PD Modification Application: PRS 25-0866**Zoning Hearing Master Date:** NA**BOCC Land Use Meeting Date:** September 9, 2025**Hillsborough
County Florida**

1.0 APPLICATION SUMMARY**Applicant:** Matt A. Borich**FLU Category:** R-1**Service Area:** Rural**Site Acreage:** 17.7**Community
Plan Area:** Lutz**Overlay:** Lutz Rural Area Development Standards**Introduction Summary:**

APPLICATION NUMBER: PRS 25-0866

**Site Plan** MM 05-0791
Scale: 1" = 100'

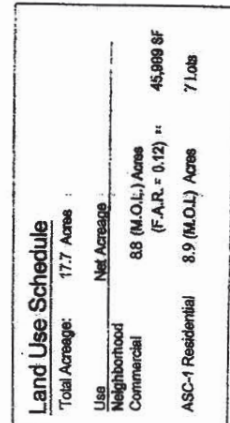
The applicant is requesting to allow the required buffer area adjacent to folio 33448.0000 to be included as part of the lots, rather than a separately platted buffer tract. The applicant indicated the practical difficulty in having a separate tract as the small subdivision will not have a Homeowner Association or similar entity to separately maintain the buffer area. To maintain compatibility with the adjacent property, the applicant has proposed a 35-foot setback adjacent to folio 33448.0000 for all buildings/structures. This 35-foot setback for the principal building adjacent to folio 33448.0000 would be the same as the setback required by the required ASC-1 development standards if the 20-foot buffer was maintained as a separate tract (i.e. 15-foot setback, plus 20-foot buffer). Additionally, the increased setback would be greater than what is required for accessory structure which would have been permitted a 3-foot setback adjacent to the buffer and 23 feet from folio 33448.0000 if the buffer were to be separate tract. No increase in the number of approved lots is requested under PRS 25-0866.

Furthermore, with the 2005 modification of the original PD, which was zoned for commercial uses, the residential component was added to the northern portion of the PD and screening was required between the use types. Therefore, the residential portion was required to provide screening along the shared property line. Through the platting process it was discovered that the area where the landscaping/screening is required contains significant wetlands.

5. The developer shall provide a minimum 15-foot-wide landscape buffer strip between the road right-of-way and the parking area/~~single-family lots~~ along Livingston Avenue. ~~The developer shall provide a 20-foot buffer around the existing single-family residence in the residential portion of the project as shown on the general site plan. Said buffer shall not be platted as part of the individual lots.~~ The developer shall be permitted to provide access through the project for the adjacent single-family residence. No buffer shall be required between the residential and the commercial portions of the project. ~~However, screening shall be provided in accordance with the LDC.~~
